Submission: Bluestone Hardrock Quarry Project (SSD – 76210271)

Position: I object to this project

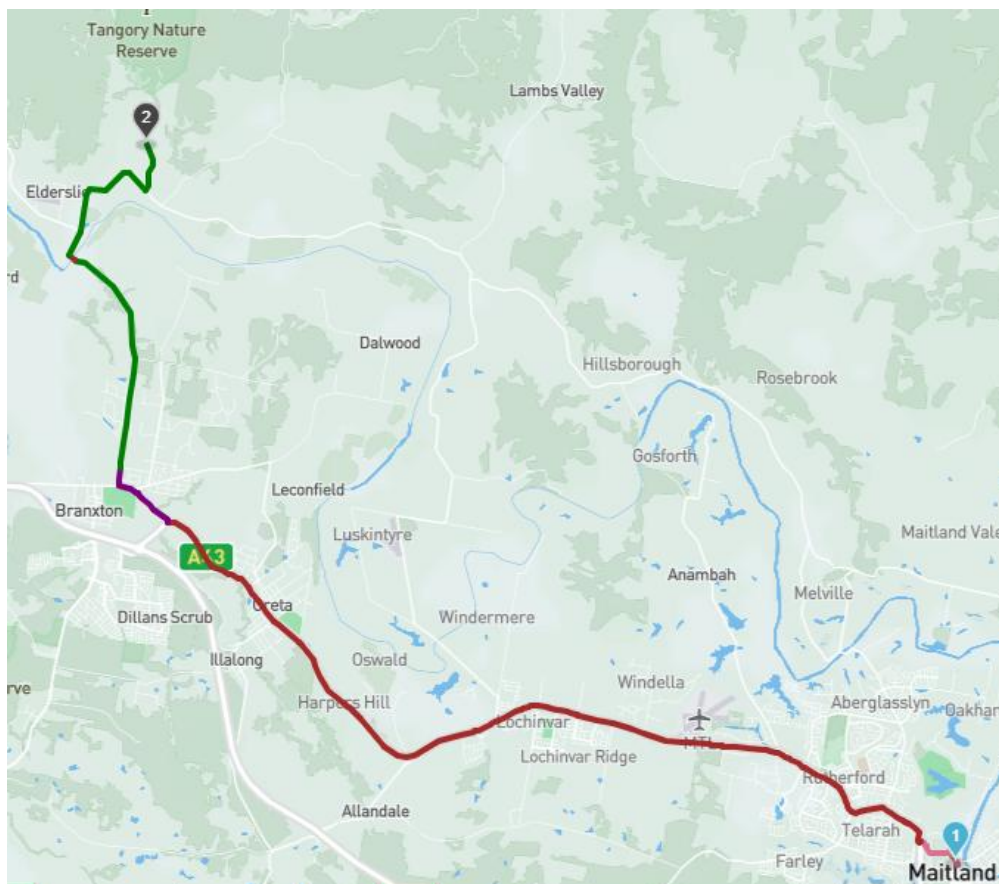
A. The official proposed haulage route is not fully described per the explanations used.

- Mapped version of Haulage Route: At the beginning of the EIS Summary [Fig 6 Page 26], the official haulage route is described as including only Springvale Road, Stanhope Road from the junction with Springvale Road to the Elderslie Road intersection, and then Elderslie Road to the intersection with the New England Highway (AKA Maitland Street). From there it is stated to include the New England Highway to the intersection with Wine Country Drive and then proceeding onto the Hunter Expressway Interchange roundabout but with no defined direction of travel from that point. [See map below]

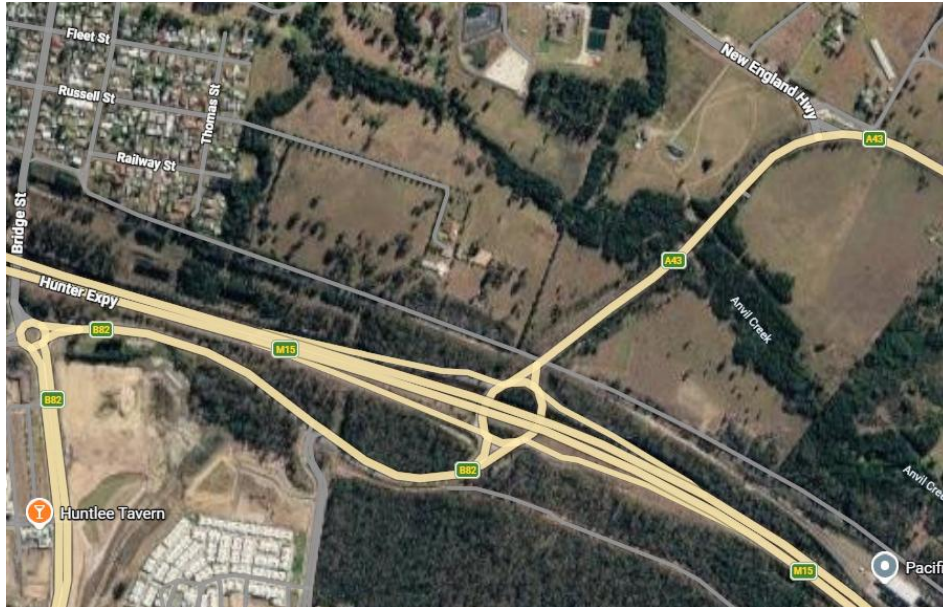
- E.G. A map of the 'official' haulage route (which does not include the supplementary New England Highway to Rutherford/Maitland route) fails to describe the use of the Branxton/Wine Country Drive off ramps from the Hunter expressway and the interchange roundabout to reach Branxton and the junction with Elderslie

Road and hence the proposed quarry project in Springvale Road, via Stanhope Road. [Compare the 'official' Haulage Route Map in point A with the map of the Hunter Expressway interchange on Wine Country drive below]

▽ Site: 101 [NEH & Elderslie Rd_2025_AM_Base (Site Folder: General)]

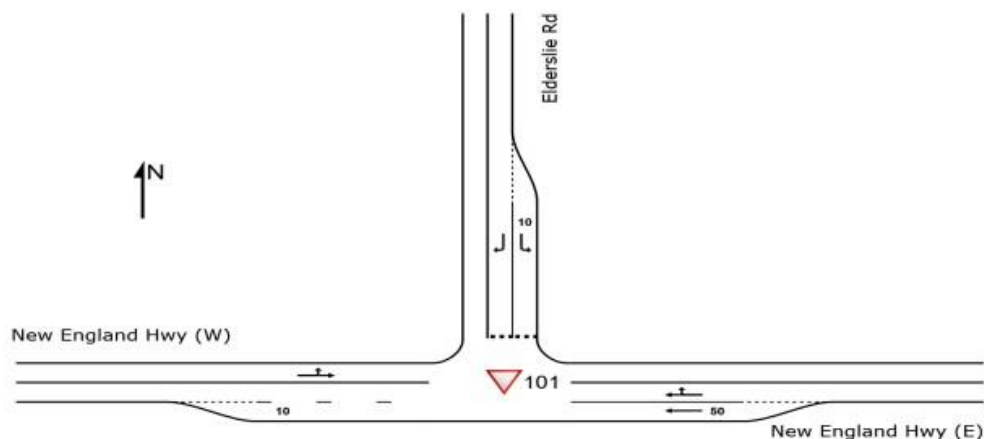
- To highlight this concern further , the measurements of traffic movements over a 6-day period for 60 minute periods in both the am and pm (times unspecified) , recorded at Site 101, which studied traffic flows at the Elderslie and Stanhope Road intersection, and was also included in the Integrated Traffic and Trasport Assessment documentation, clearly indicates that Stanhope Road Eastbound, had an hourly AM hourly average of 73 movements and a hourly PM average of 60 movements and that Stanhope Road Westbound (direction of the proposed haulage route) had an hourly AM average of 47 movements and a PM hourly average of 98 movements ,

- These figure for Site 101 recorded for merely 6 days for one-hour period in both the morning and afternoon, suggest very

strongly that the Traffic Survey Data figures gained at Site ^ equipment located just outside a property gate on Stanhope Road)) may either have been corrupted or misrepresented.

Figure 1 - Project Layout and Pipeline Interaction Plan

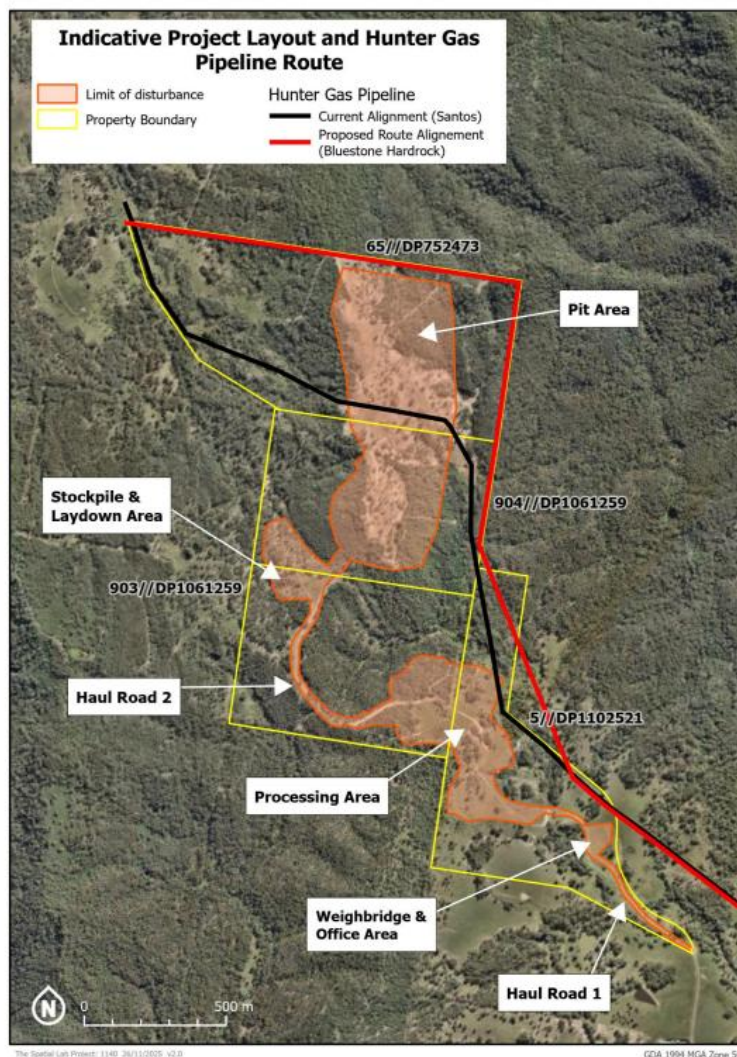
See following map of the proposed relocated pipeline easement route [from Appendix V] as suggested by the Quarry proponent:

- The proponent's suggested realignment of the QHGP route, to follow the northern and eastern boundaries of the proposed quarry project before rejoining the original QHGP route through the lower, less heavily treed section of the Tangory Nature Reserve, would vastly increase impacts on the native habitat on both sides of the boundary with the Tangory nature Reserve due to the now required 50m wide temporary Construction Easement as well as the permanently cleared final 30m wide Pipeline Easement.
- That level of clearing of native bushland was not accounted for within the QHGP 2009 Approval nor the decision to allocate that project a "Not a Controlled Action" Status.
- The suggested realigned route along the boundary with Tangory nature Reserve lands would also create greater topographical

challenges for the construction of the pipeline and result in greater impacts on several major tributary (seasonal) creeks that flow into Dutton's, then Stanhope Creek and ultimately the Hunter River.

- The suggested second plan (also stated in Appendix V) to located the pipeline (via directional hydraulic drilling) over 110m underground but within the quarry pit footprint would not only create major geological constraints and difficulties for the QHGP construction process but also create a major pipeline operational risks and hazard (vibration damage impacts are a major hazard and risk for buried High pressure Gas transmission Pipelines) which could threaten the integrity of the pipeline.

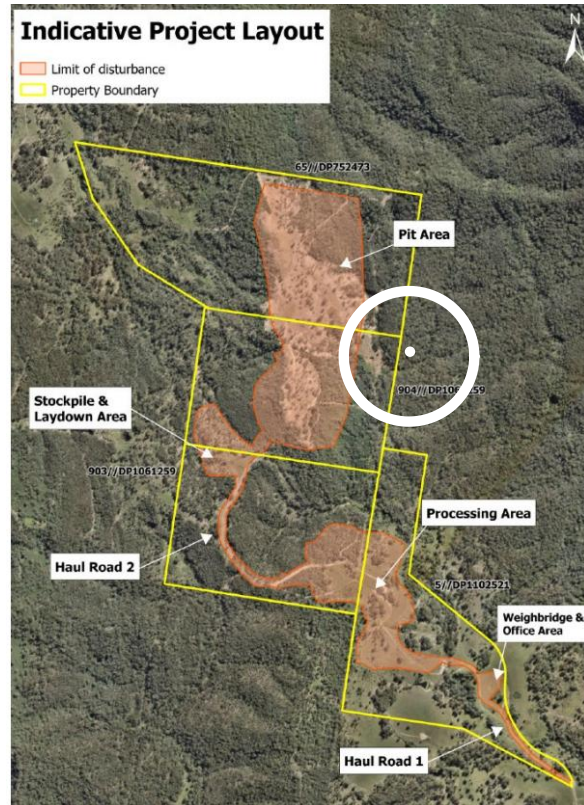
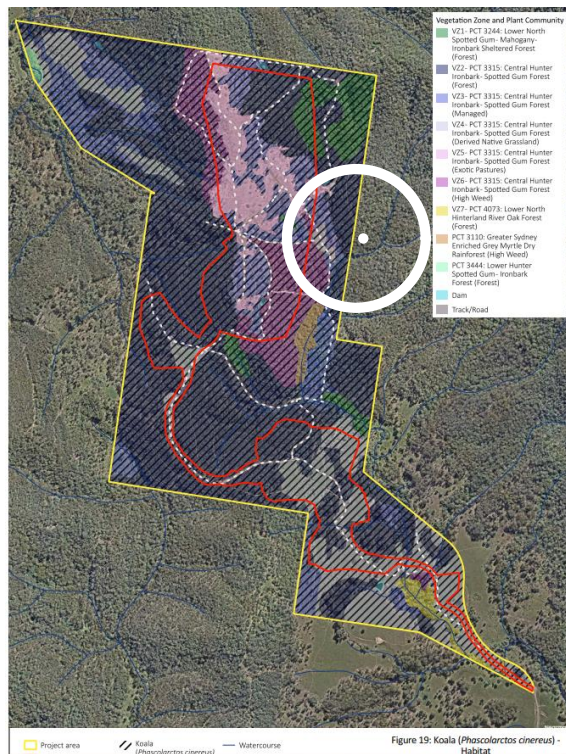
- See following Koala habitat map from Appendix G - MNES Assessment and a map of the Indicative Project Layout (Limit of Disturbance), both showing the location of where the recording of the male koala was taken in 2024 via a circled white dot and compare with the map (sourced from NSWNPWS in January 2026) showing the location (inside the red circled area) where the recording of the male koala was made in 2024.
- The distance from the Project Disturbance footprint is just over half a kilometre – not 5kms away, as claimed in the Projects MNES Assessment.

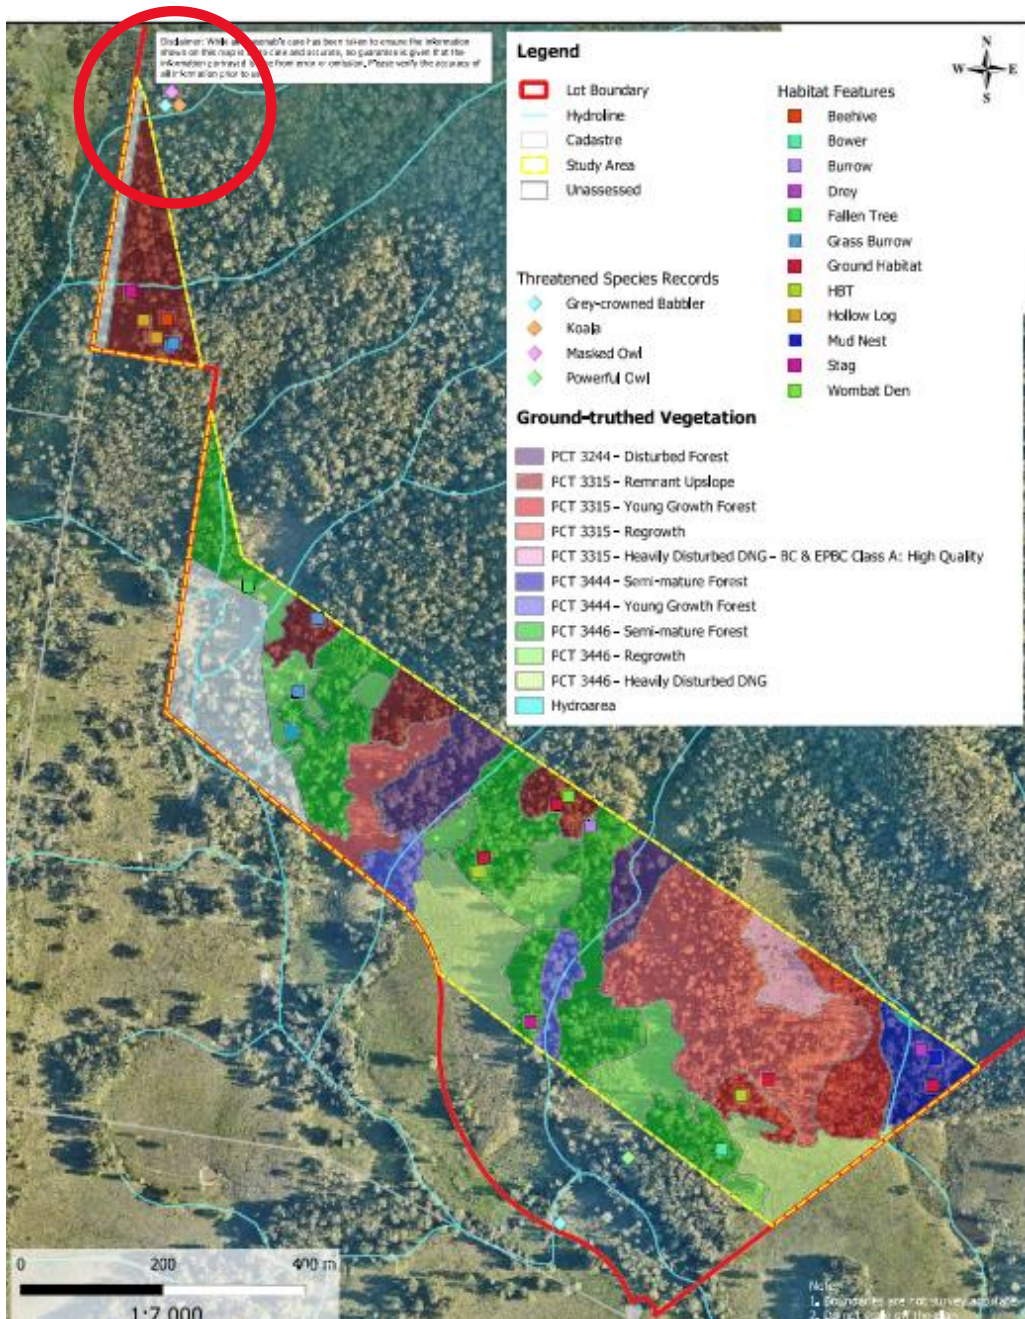
- See the following map from the Santos/HGP Pty Ltd fauna survey effort (supplied by NSWNPWS), showing where the location of the recording of the male Koala as taken in 2024 within a red circle.

- The loss of not only potential koala habitat so close to the location where this male koala was recorded calling as well as the potential source of a noise and dust pollution and extensive human activity associated with the development and operations of the Project may result in a potentially emerging new koala colony, either within the Tangory nature Reserve, or on nearby landholdings, failing to establish or, if established already to be driven away.

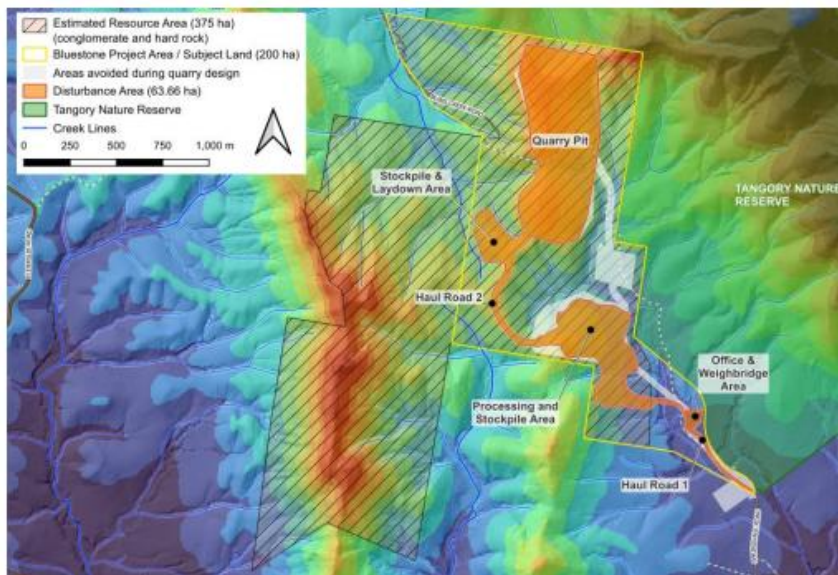
It is believed that there is a strong likelihood that the proponent, or any future owner of Bluestone Hardrock Quarry, if the project is approved, may later apply to expand the area to be quarried into this other, already mapped resource area, creating further local environmental losses and associated impacts and potentially increasing the number of movements on the haulage route.

- On Page 60 Appendix D – MNES Assessment there is a map that also appeared in the 2024 Scoping Report.
- The map shows the ‘estimated resource area’ on several properties owned by the proponent. In the Scoping Report, however not all are included in the Project application.
- There are major concerns that at some point in the future, if this project is approved, that a modification for an expansion to the
